DART AEROSPACE LTD	Work Order: 711248
Description: Crosstube Assembly (205/212/412 High Fwd)	Part Number: D212-664-141
Inspection Dwg: D212-664-141 Rev: D	Page 1 of 1

DRAWING NO. D212-664-141	TITLE XTUBE ASSY (205/212/412 HI FWD)	REV. D	DART AEROSPACE LTD ENGINEERING ORDER		D.E.O. NO. D212-664-141-D-1	SHEET NO. SHEET 1 OF 2	SCALE NTS
DRAWN	CHECKED	OP	MFG. APPR.	RE	APPROVED	MP	DE APPR.
DATE 11.04.07	DATE 11.04.11		DATE 11.04.12		DATE 11/09/12		DATE 11.04.12

ADD AN INSPECTION WINDOW TO UNDERSIDE OF CROSSTUBE.

DRAWING NO. D212-664-141	TITLE CROSSTUBE ASS'Y (205 HI FWD)	REV. D	DART AEROSPACE LTD ENGINEERING ORDER		D.E.O. NO. D212-664-141-D-2	SHEET NO. SHEET 1 OF 1	SCALE NTS
DRAWN <i>UP</i>	CHECKED <i>ADS</i>	MFG. APPR. <i>ES</i>	APPROVED <i>MD</i>		DE APPR. <i>HT</i>		
DATE 11.07.15	DATE 11.07.20	DATE 11.07.21	DATE 11/07/21		DATE 11.07.21

**D212-664-141/-141B
ASSEMBLY DETAIL**

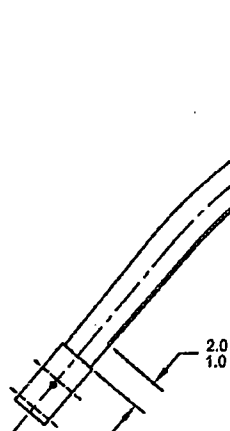
NOTES 2 OF SHEET 1 IS AMENDED AS FOLLOWS:

MASK AREA PRIOR TO PAINTING,
REMOVE MASKING AFTER PAINT
AND APPLY CLEAR COAT

- 2) FINISH: CHEMICAL CONVERSION COAT PER DART QSI 005 4.1
PRIME INSIDE AND OUTSIDE PER DART QSI 005 4.2
MASK UNDERSIDE OF CROSSTUBE AS SHOWN (HATCHED AREA) AND
PAINT OUTSIDE PER DART QSI 005 4.2
REMOVE MASKING AND APPLY CLEAR COAT
